Transmitted herewith is the Value Analysis
Report of the Triple Pole Receptacle (GE-3000).

Value Analysis
Wiring Device Division

VALUE ANALYSIS
of
TRIPLE POLE RECEPTACLE
GE-3000

SLEEVE NUT (1 Req'd.)
4191344

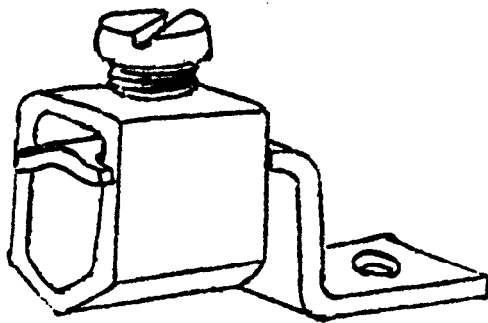
Eliminate
Use standard 6/32 square nut - \$1.10/M

COMMENT: This change brings about a necessity for a change in the length of the 6/32 x 1½" steel screw used to hold the cover in place. This screw should be 1/8" longer or 6/32 x 1-5/8".

In order to hold the square nut in place when the cover is removed, it is proposed that the nut be covered with pitch at the same time that three other holes are filled.

STRAIGHT CONNECTOR (1 Req'd.)
(Vendors #45025)

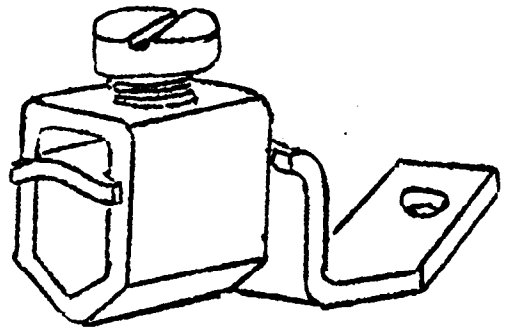
Replaces center terminal, cap, washer, and strap.

COMMENT: This connector can be purchased with a tapped hole for \$4.71/M additional. It is proposed that a self-tapping screw be used.

A similar connector is made by General Electric (GE-3239). This connector is available for \$42.92/M.

RIGHT CONNECTOR
(Vendor #45027)

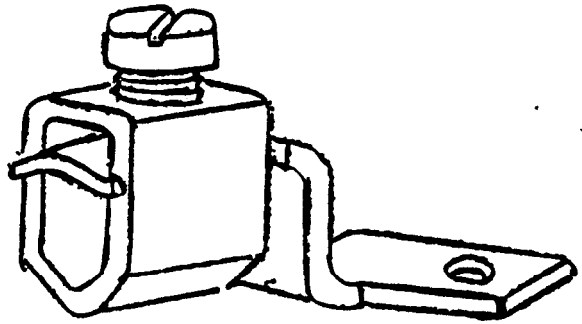
Replaces right terminal, cap, washer, & strap.

COMMENT: This connector can be purchased with a tapped hole for \$4.71/M additional. It is proposed to use a self-tapping screw.
